DOCKET**08-AFC-9**DATE MAR 12 2010RECD. MAR 16 2010

From: Will Walters <WWalters@aspeneg.com>
To: Felicia Miller <Fmiller@energy.state.ca.us>
Date: 3/12/2010 3:19 PM
CC: Jim Adams <Jadams@energy.state.ca.us>
Attachments: F4107D-6.6-10B Fogging Freq Curve.pdf; Data 10 cell back to back Clearsky.doc; Data 10 cell back to back.doc; F488-5.3-10B Fogging Freq Curve Estimate for Back t o back tower.pdf; CSVP Linearity Assumption.docx; Compute Dew Point Temp.pdf

Date: March 10, 2010
To: Will Walters, Aspen Environmental
From: Howard Balentine
Subject: Assumed linearity of RH with Temperature in CSVP

Figure 1. Dew Point Temperature over the RH Range for Selected Air Temperatures

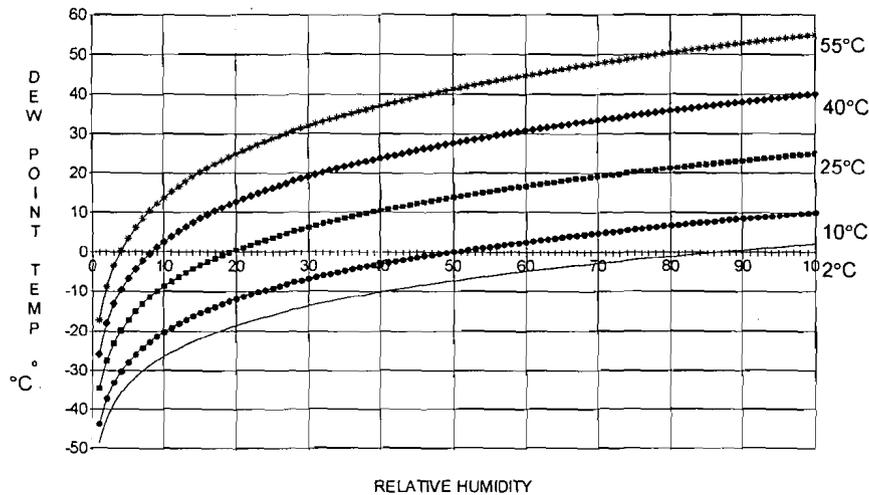
For most of the relative humidity range, linearity is a valid assumption. However, once the relative humidity drops below about 25%, the linearity assumption begins to break down. This is demonstrated in the attached PDF file from Campbell Scientific that includes a plot with curves of Relative Humidity versus Wet Bulb temperature for various temperatures. The plot of interest (Figure 1) is extracted below:

For projects in the desert such as the PHPP, ambient relative humidity can drop below 25% and so there will be a bias in CSVP due to the linearity assumption for these hours with low humidity. However, for many cases, this is not significant since under low humidity conditions, visible plumes are of lesser concern.

Model F488-5.3-10B
 Number of Cells 10
 Motor Output 200HP
 Motor RPM 1800
 Fan HP7336-7
 Fan RPM 137
 (Full Speed)

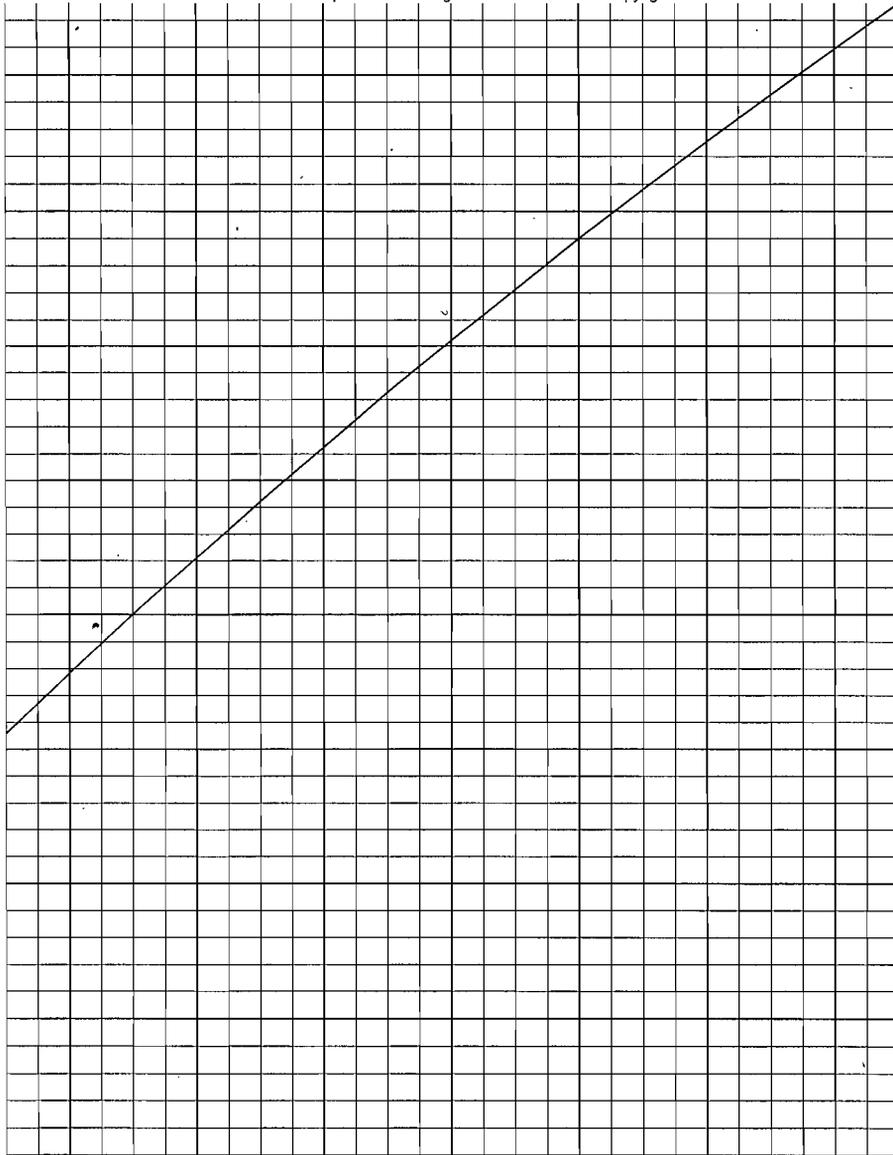
- 5) Additionally, the limited modeling results provided are inconsistent with the fogging frequency curve provided. Based on the fogging frequency curve the overall plume frequency should be somewhere around 50 percent of all hours, while the applicant's modeling results notes only 10 percent.

- 7) The fogging frequency curve provided for the proposed tower suggests that plumes would be a frequent occurrence during seasonal clear daylight hours and supports the need for a KOP simulation.
